Re: PA23-004 – Gamlam Subdivision – Technical Review 1

SUBJECT: PA23-004 Gamlam Subdivision
5811 87th Avenue NE
APN: 00590700001900

RE: Gamlam Plat, File# PA23-004
12 Lot Subdivision
5811 87th Ave NE

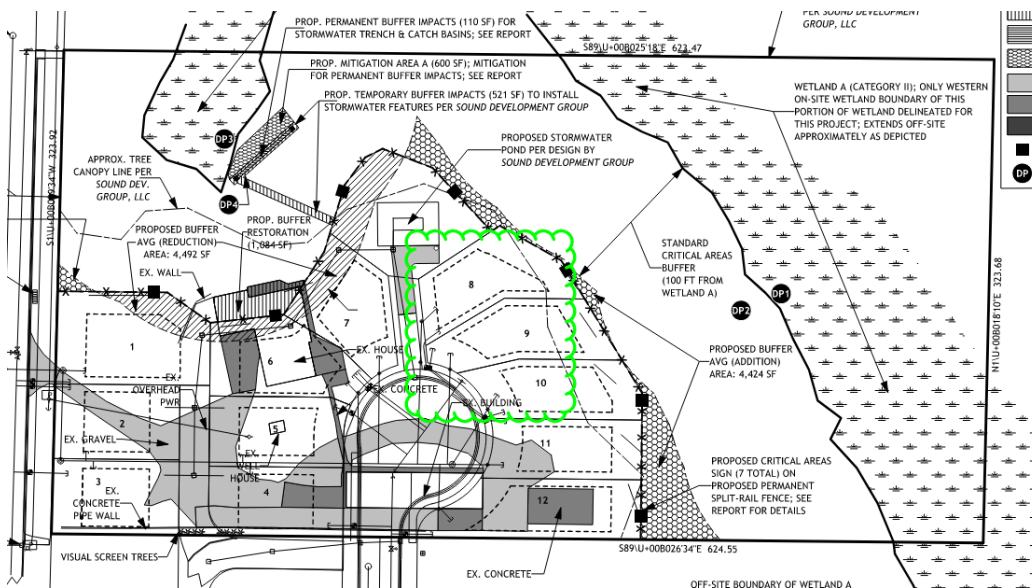
4. Lot 9 does not appear to meet the minimum lot width of 40 feet. Lot width is the horizontal distance between the side lot lines measured on a line intersecting at right angles the line of the lot depth 30 feet from the front lot line. Please revise lot 9 to meet the minimum lot width.
5. The Geotechnical Report is labeled as 'Draft' in multiple locations. Please provide a final Geotechnical Report with the next submittal.
 - 5.1. Once a final Geotechnical Report is submitted, it will be reviewed and additional comments may be provided.
6. Amend civil plans to add the top and the base elevations for any/all retaining walls.

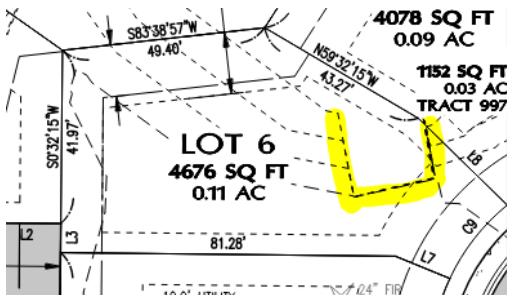
13. Before the City can issue approval of the critical area report and mitigation plan, Wetlands & Wildlife, Inc. shall conduct two (2) additional test pits in the area indicated below and provide an addendum to the report dated February 15, 2023
